**Addendum No. 06**

**Subject:** Edward Gideon School  
SDP Contract No. B-055C OF 2018/19

**This Addendum, dated January 8<sup>th</sup>, 2020 shall modify and become part of the Contract Documents for the work of this project. Any items not mentioned herein, or affected by, shall be performed strictly in accordance with the original documents.**

DRAWING NO.  
**ESP1.0**  
SHEET 31 OF 45

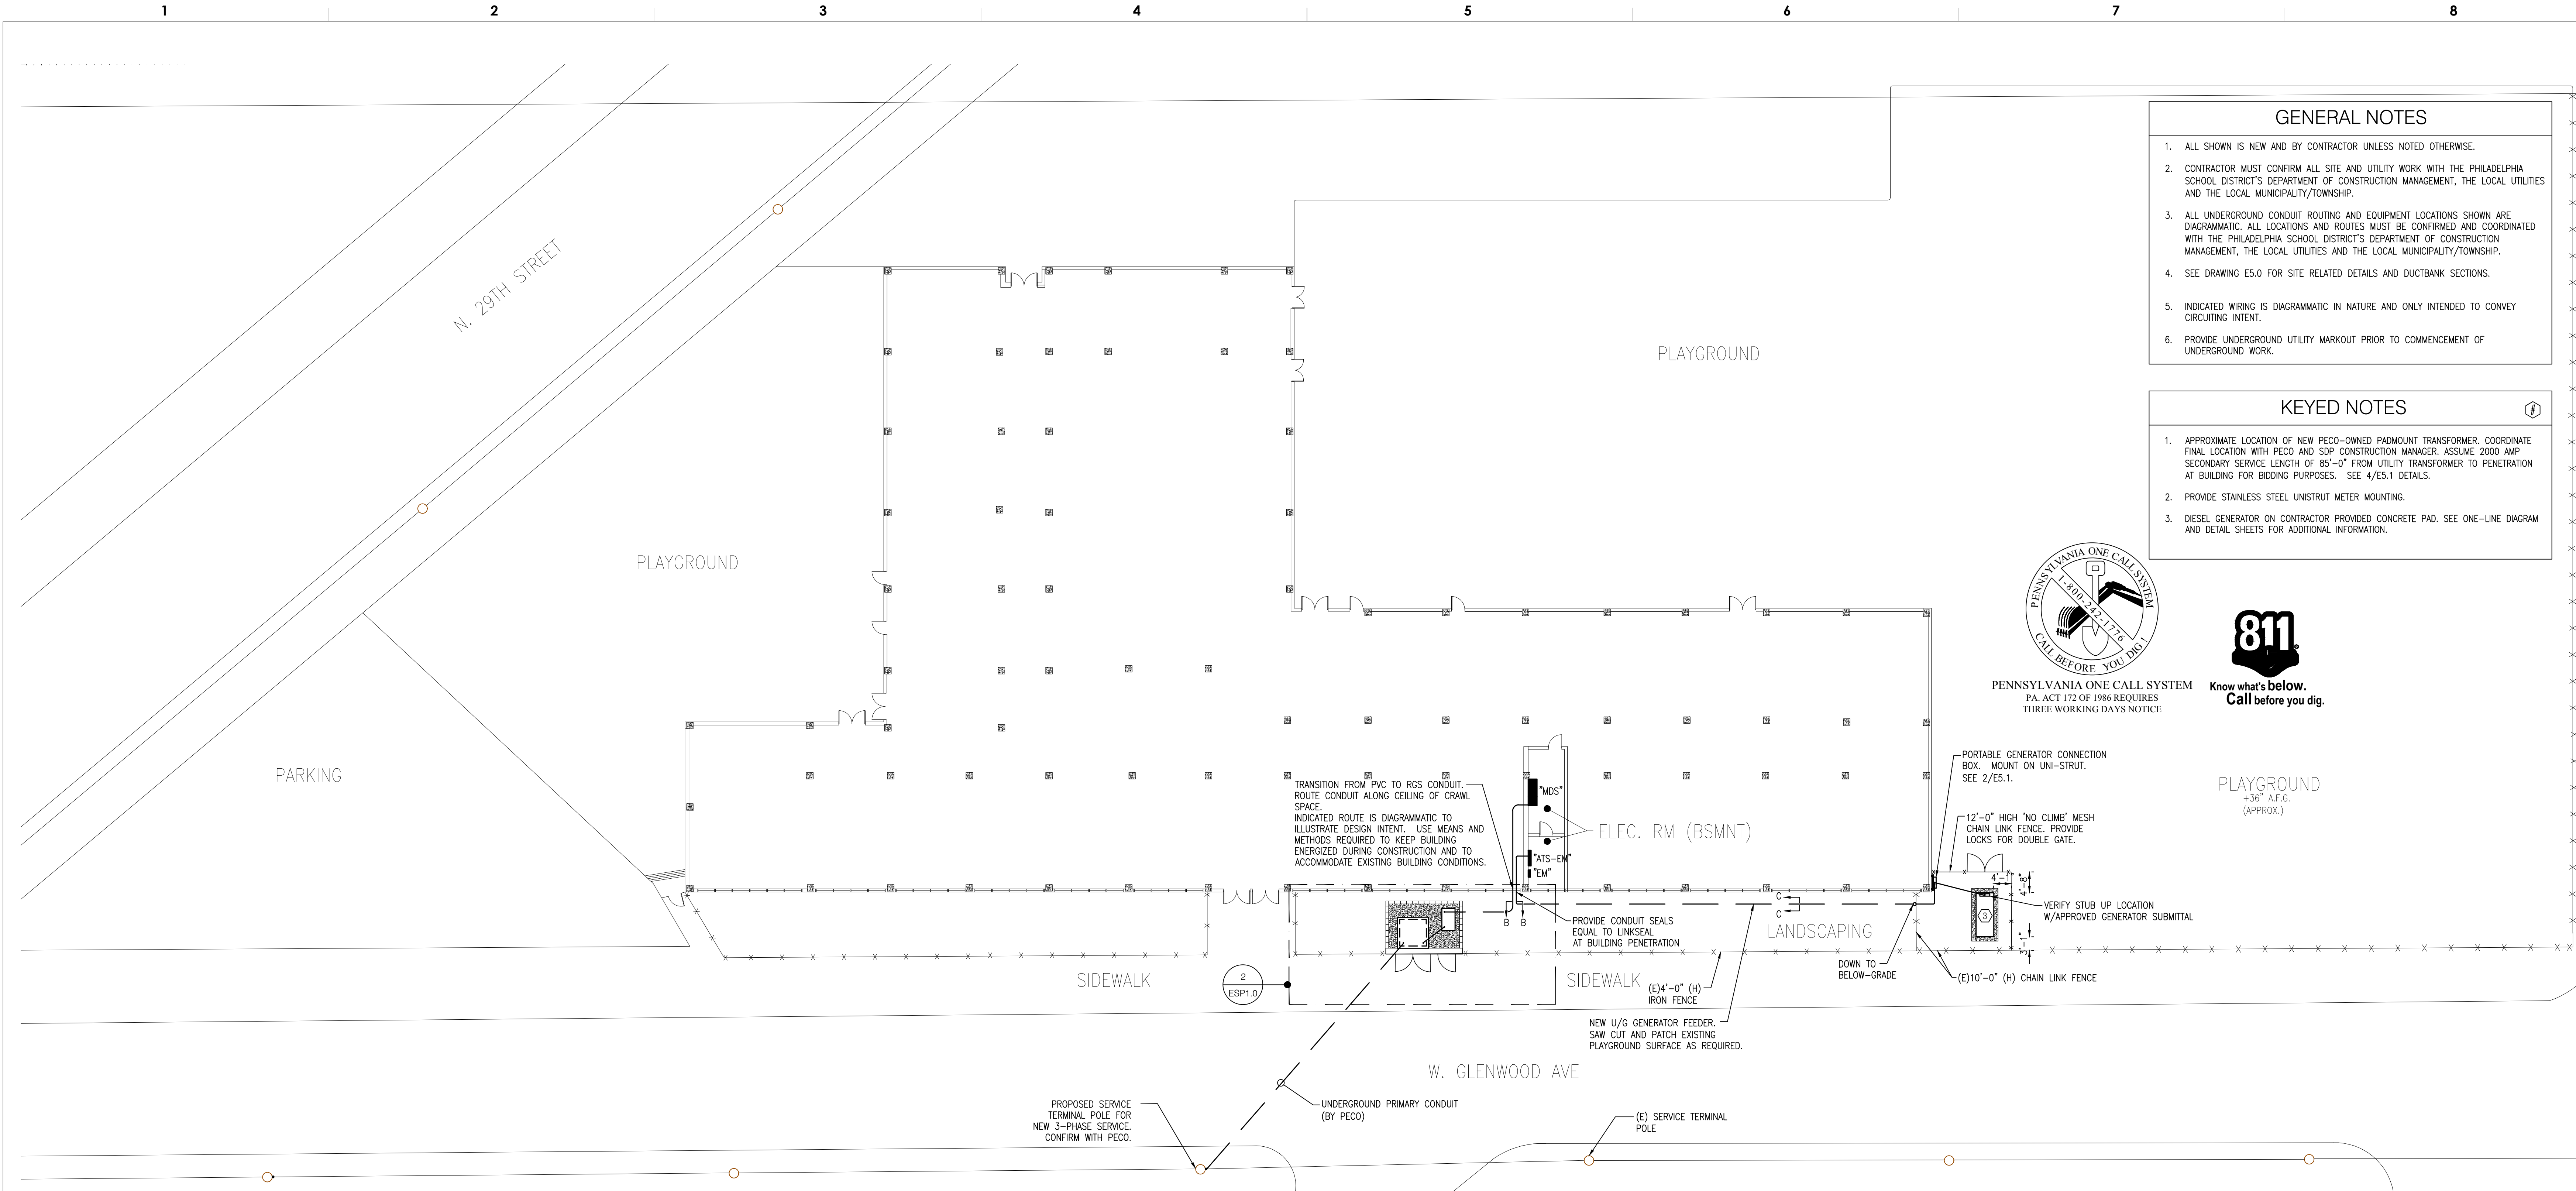
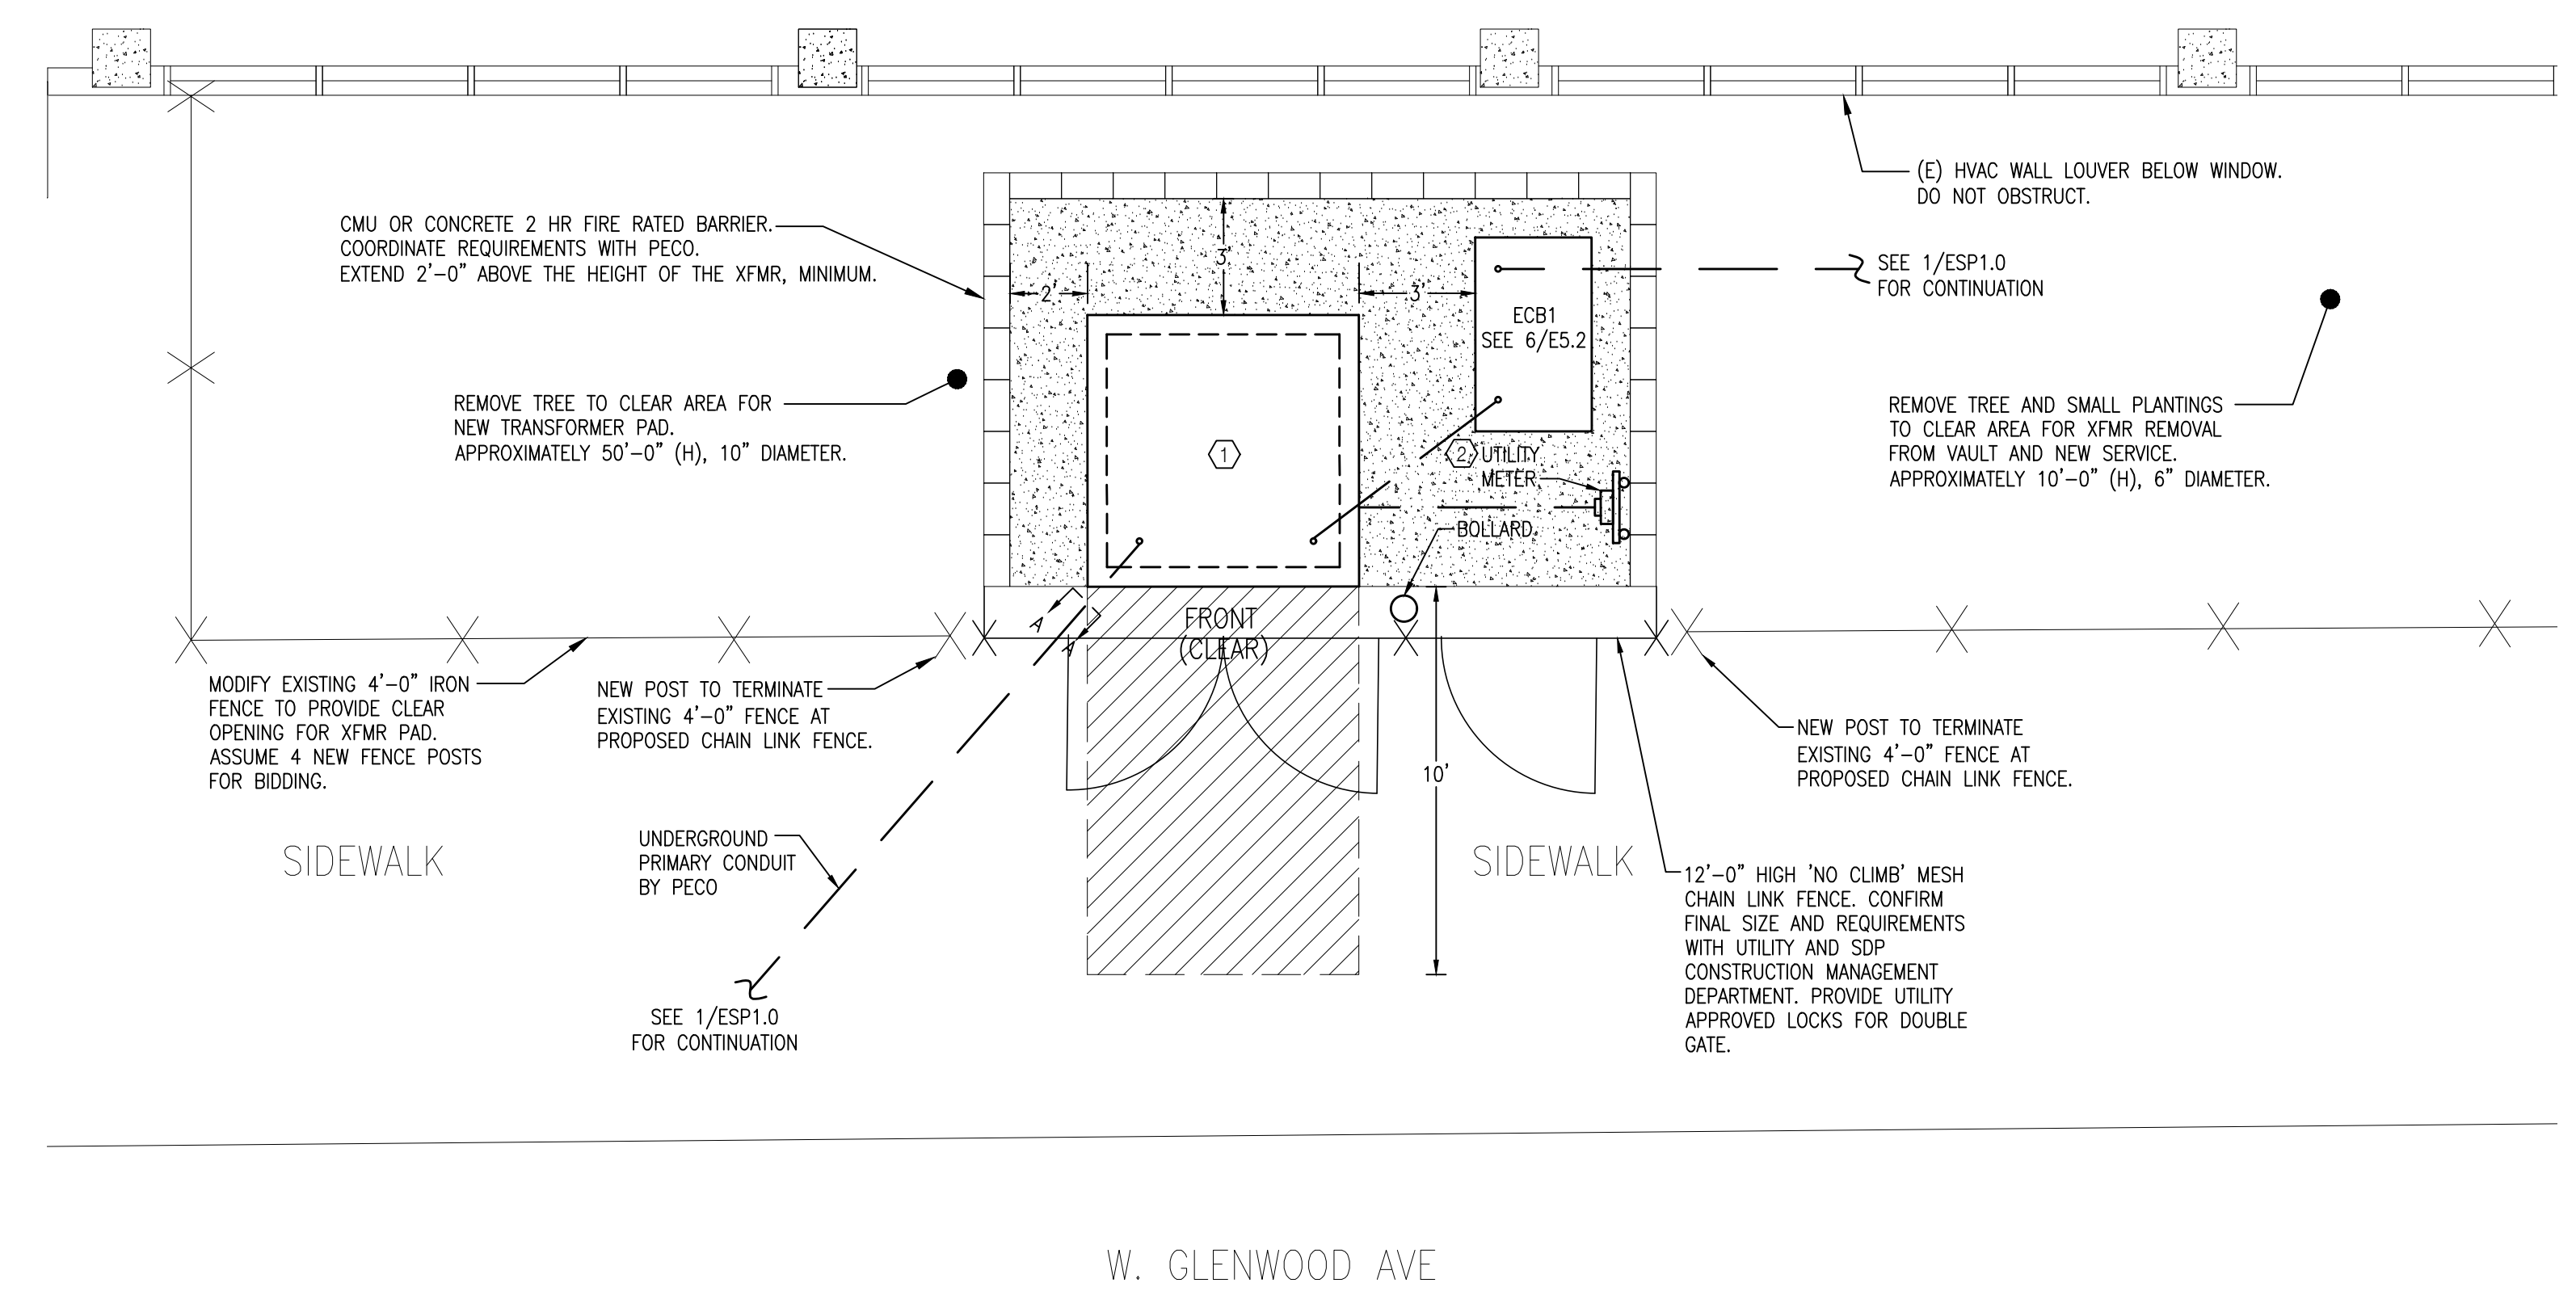
A transformer specification has been added to the project. See attachment. The specification lists manufacturers of phase change transformers. Phase change transformers are custom made and a standard written guide specification is not available from the transformer manufacturers.

1 FIRE ALARM RISER DIAGRAM  
FA4.0 SCALE: NONE

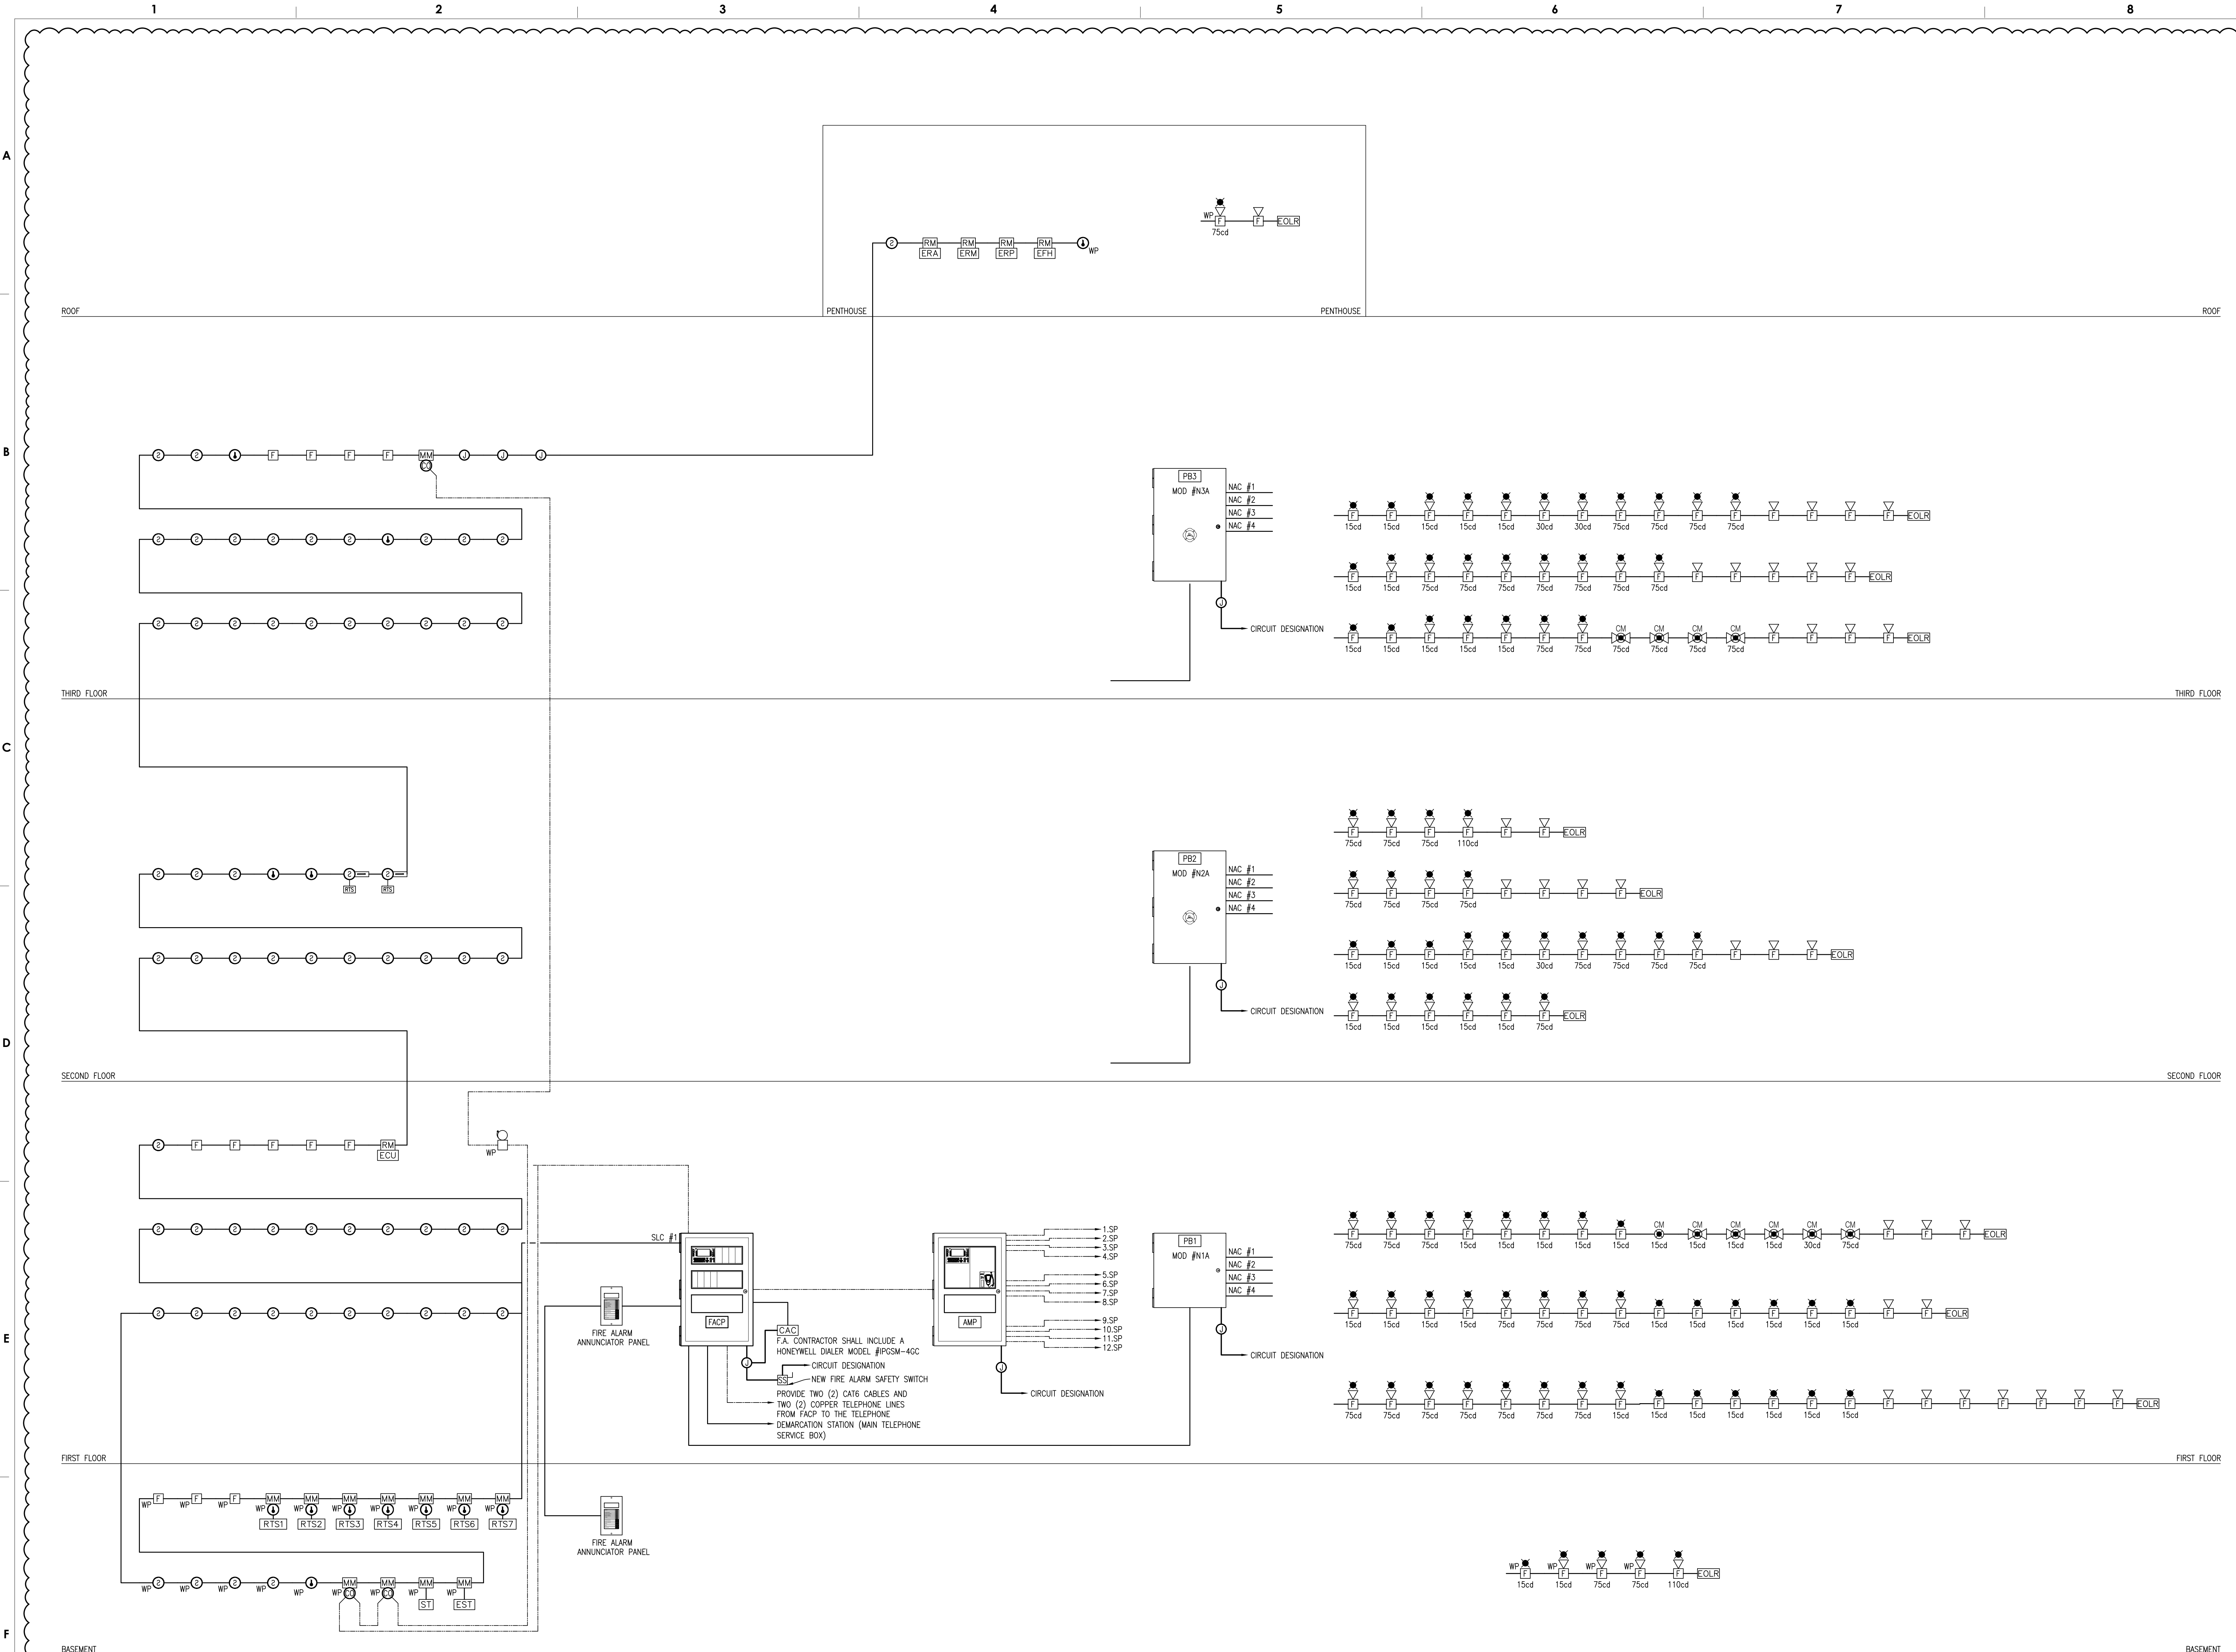
Please advise if a Gamewell/FCI Fire Alarm Control Panel/System is an acceptable alternative for Spec Section 28 4621.11 on the above mentioned project.”

Yes Gamewell/FCI is acceptable.
